CODE: CC-292

DATE: DECEMBER 21, 1994

SUBJECT: SERIES 2000 TRACTORS ( MODELS 2130 - 2185 )

FIG. 1

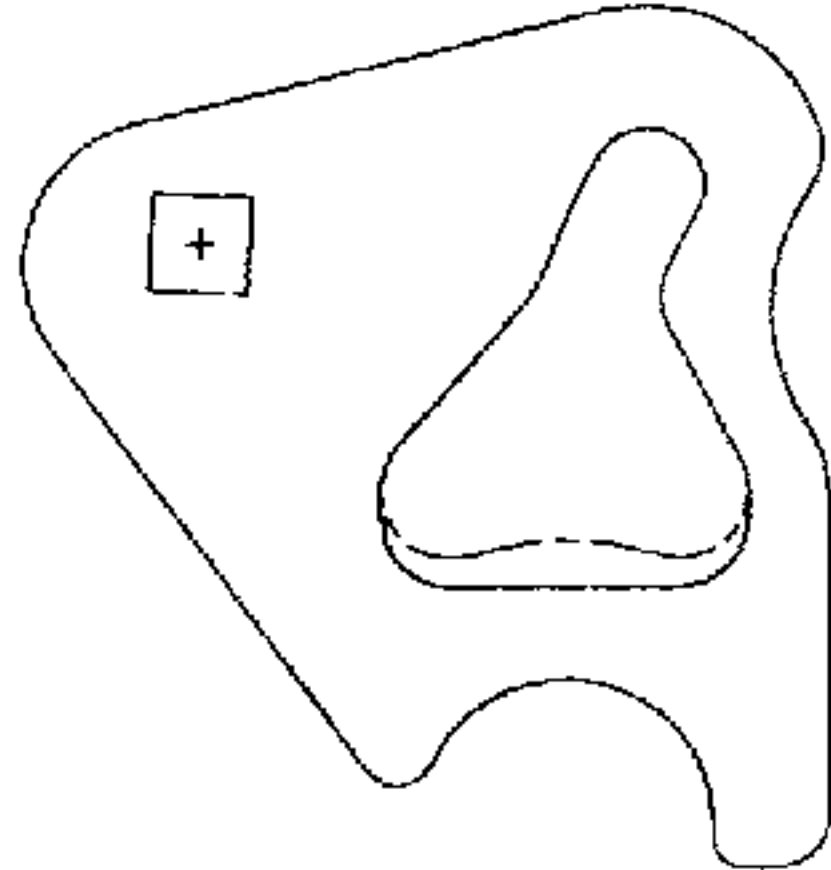
SOLUTION: REMOVE THE NEUTRAL RETURN BRACKET AND GRIND OUT THE INSIDE OF THE BRACKET FROM THE DOTTED LINE (SHOWN IN FIG. 1) DOWN APPROXIMATELY .100 TO ACHIEVE PROPER CLEARANCE FOR THE CLEVIS PIN.

FIG. 2

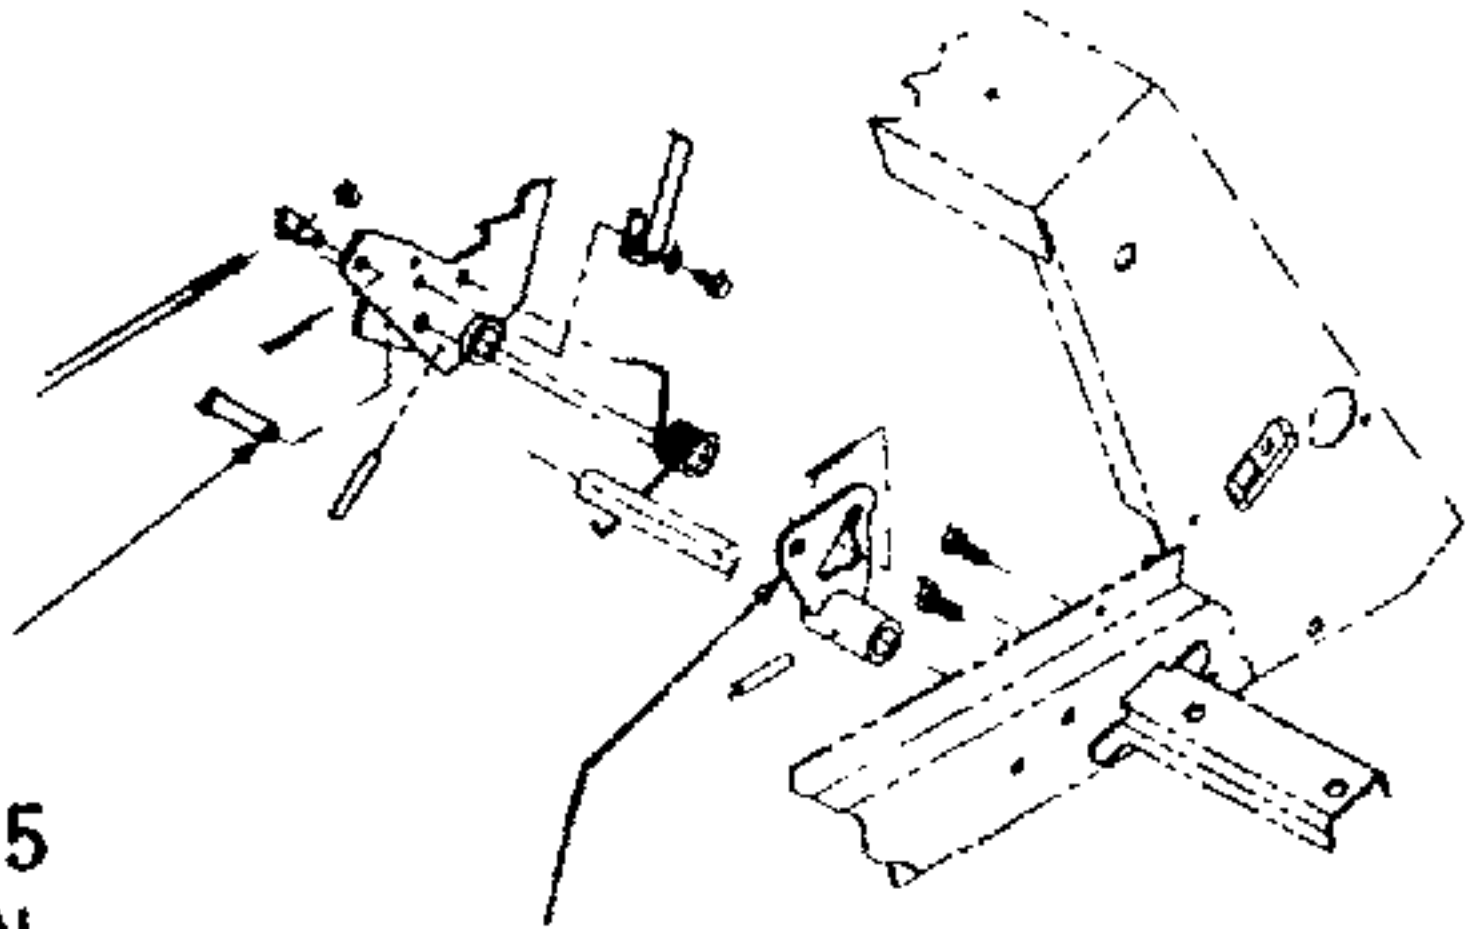
PROBLEM: WE HAVE RECEIVED SOME REPORTS FROM THE FIELD OF THE FORWARD AND REVERSE PEDALS BEING SLUGGISH WHEN RETURNING TO NEUTRAL. THE CLEVIS PIN (# 711-0415) IN SOME CASES MAY HAVE AN INTERFERENCE WITH THE NEUTRAL RETURN BRACKET (# 603-0215) SHOWN IN FIG. 2 BELOW.
